Martinez Refinery Renewable Fuels Project

Final ENVIRONMENTAL IMPACT REPORT

State Clearinghouse No. 2021020289

(County File No. CDLP20-02046)

Figure 1 -- Existing Water Lines Serving the Marathon Refinery or in the Vicinity

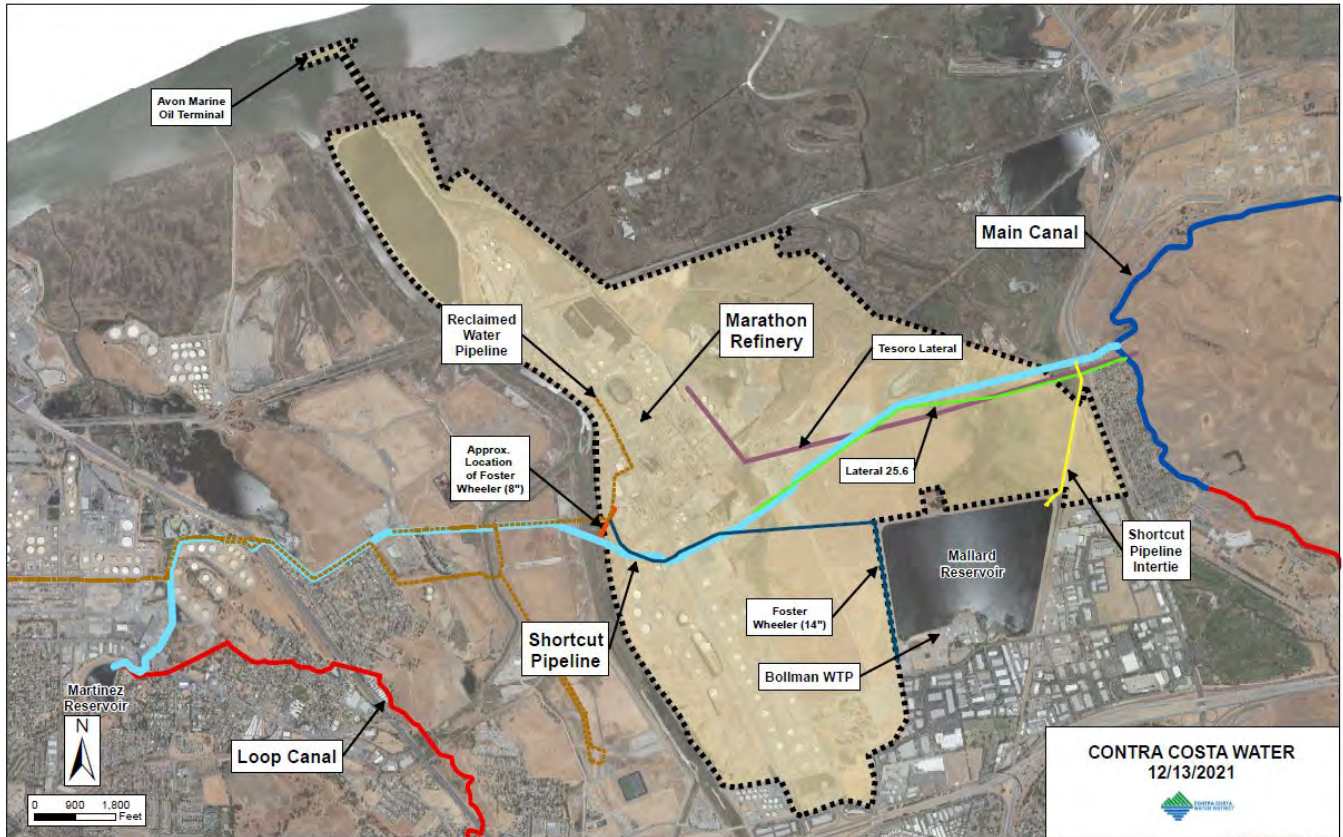
1. There are various untreated water lines that serve the Marathon Refinery (see Figure 1 below). These include the Shortcut Pipeline and Lateral 25-6, owned by the United States Bureau of Reclamation (USBR) and operated by CCWD, the Tesoro Lateral, and two Foster Wheeler lines. These water lines are not discussed in the Project EIR, so please add this information into the administrative record for this project. Protection or changes to these water lines as a result of the Renewable Fuels Project will need to be coordinated with CCWD.

Figure 3-5. Carbon Vessels for Odor Control

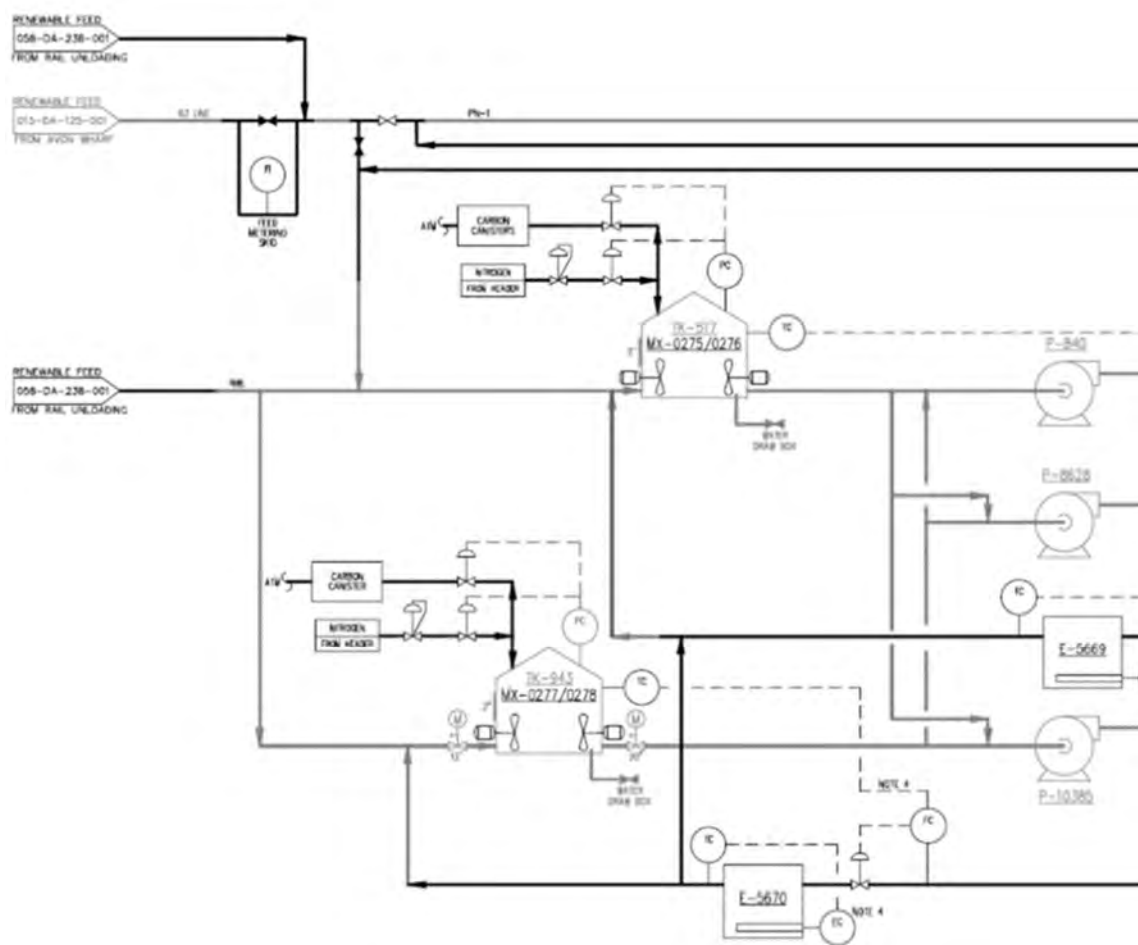
- a. The Air District does not have sufficient information to agree or disagree with the determination that with implementation of MM AQ-2 (Odor Plan) Impact AQ-5 is less than significant. Without the opportunity to review a proposed Odor Plan, it is not possible to assess its potential benefits or shortcomings.

Engineered odor controls were incorporated into the project design including provision of fixed and floating roof sealed covers on storage tanks and process vessels as well as nitrogen blanketing of the vapor space. Emissions of vapors at product loading and offloading facilities of the Refinery would continue to be collected in the Refinery’s existing vapor recovery system. Tanks that are not on the vapor recovery system would be vented through carbon canisters to capture any hydrocarbons in the vapor space. A schematic of a typical process is included in Figure 3-5.
